# **Lexington Planning Board**

Wednesday, May 7, 2025

1. 166 Spring Street Limited Site Plan Review for Muslim Community Center

Re: Project Review for 166 Spring Street: Limited Site Plan Review

EAST / WEST SECTION THRU GARAGE ENTRY

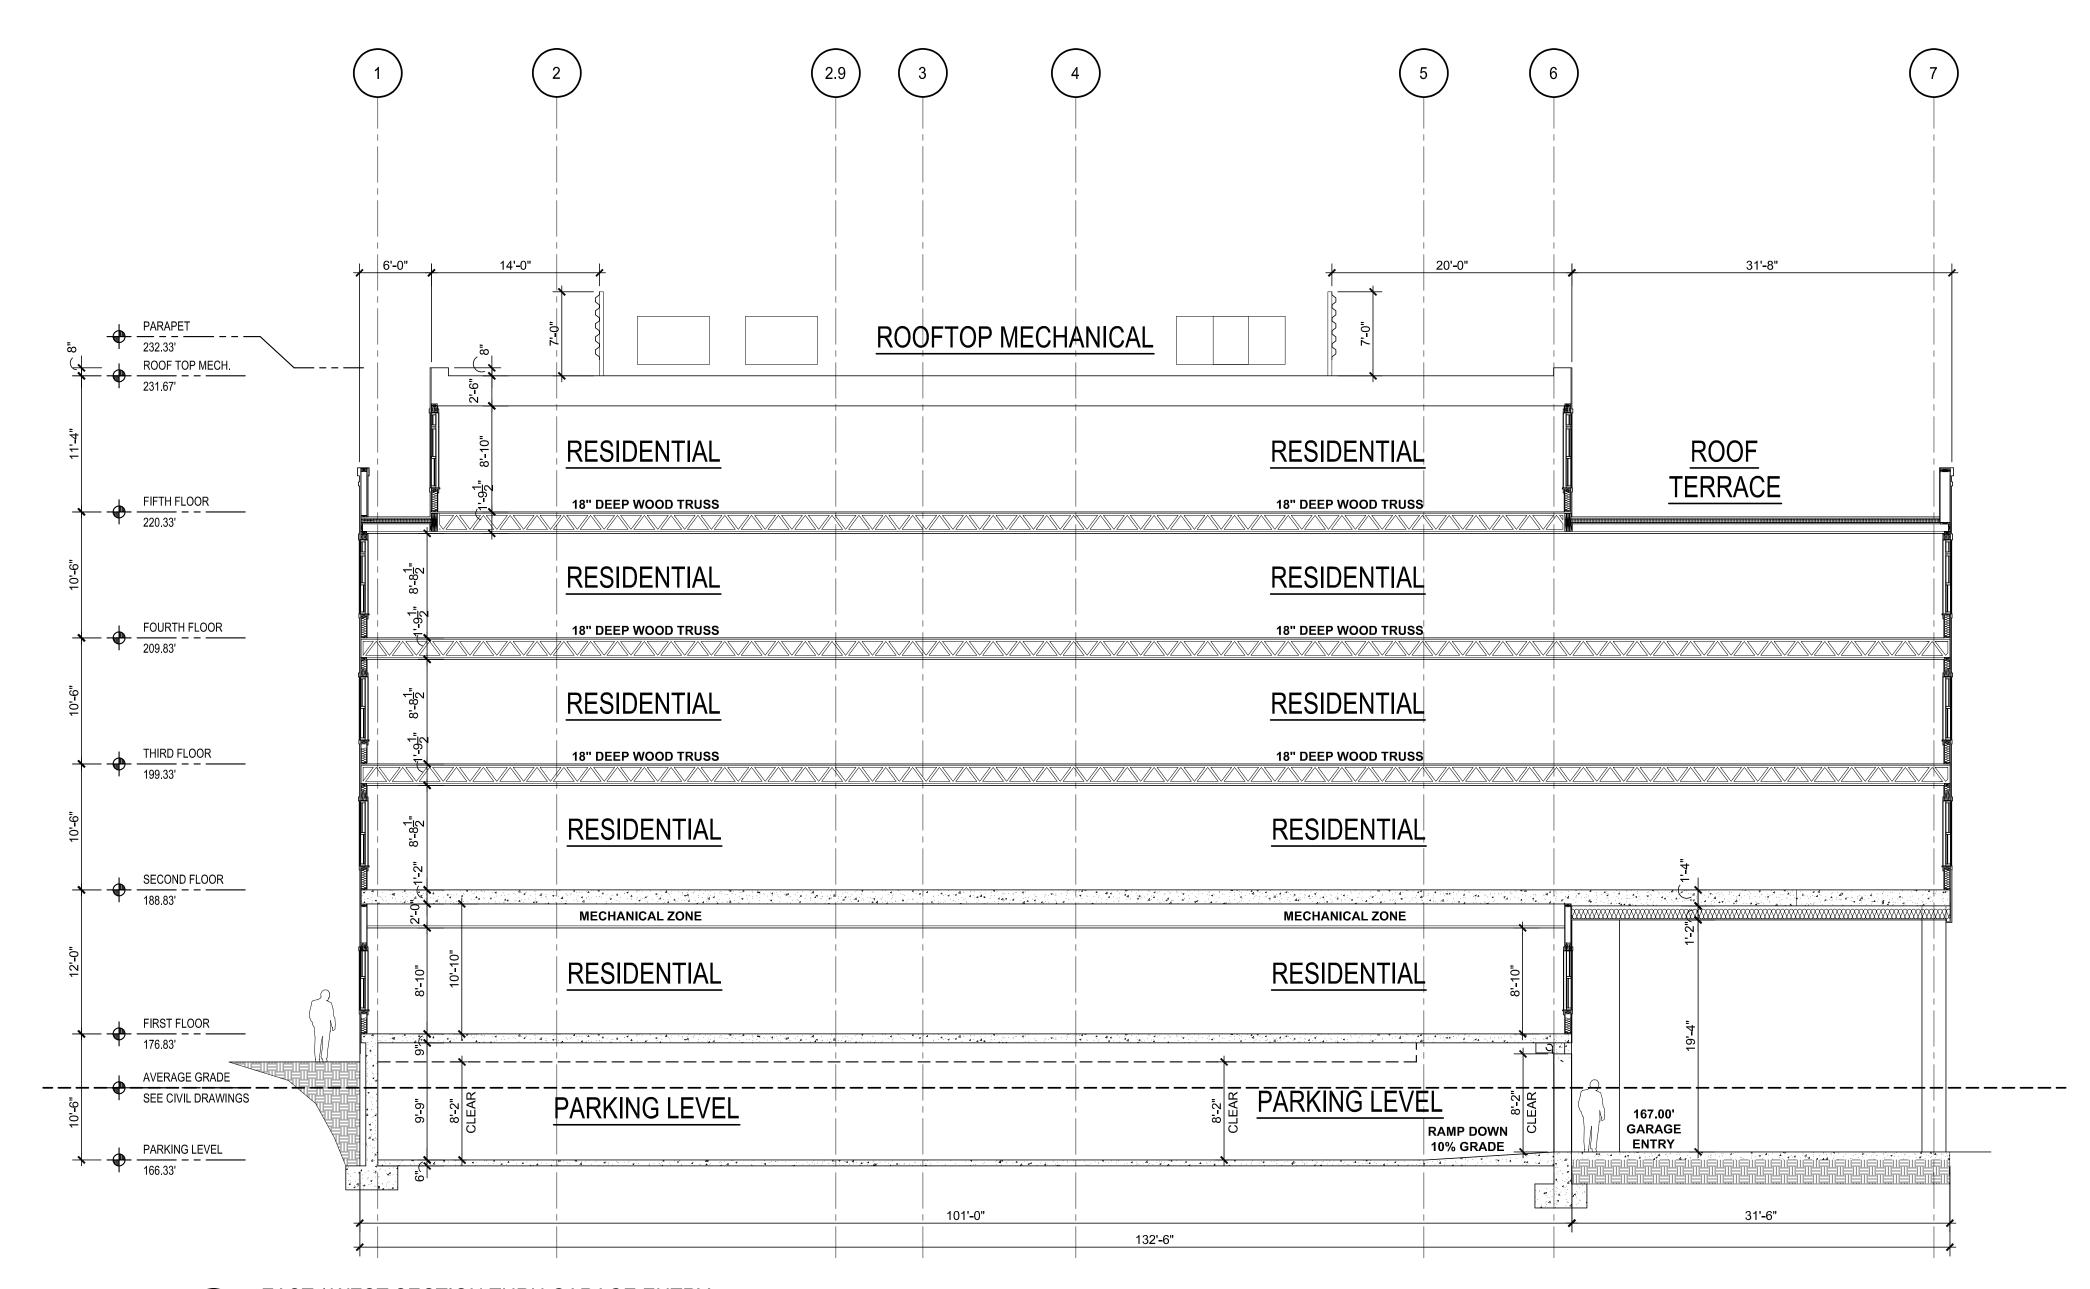
- D.) The applicant should verify the ceiling clearance in front of the dumpster pad, the Architectural plan sheet A303 shown a clearance of 19'-6". The required dumpster pick height clearance is 24 feet minimum.

- 8.7. The applicant should verify the ceiling clearance in front of the dumpster pad, the Architectural plan sheet A303 shows a clearance of 19'-6". The required dumpster front end pick-up height clearance is 24 feet minimum. The response letter stated that the trash hauling company will be able to empty by picking up, backing up, empty contents, and then drive forward to place
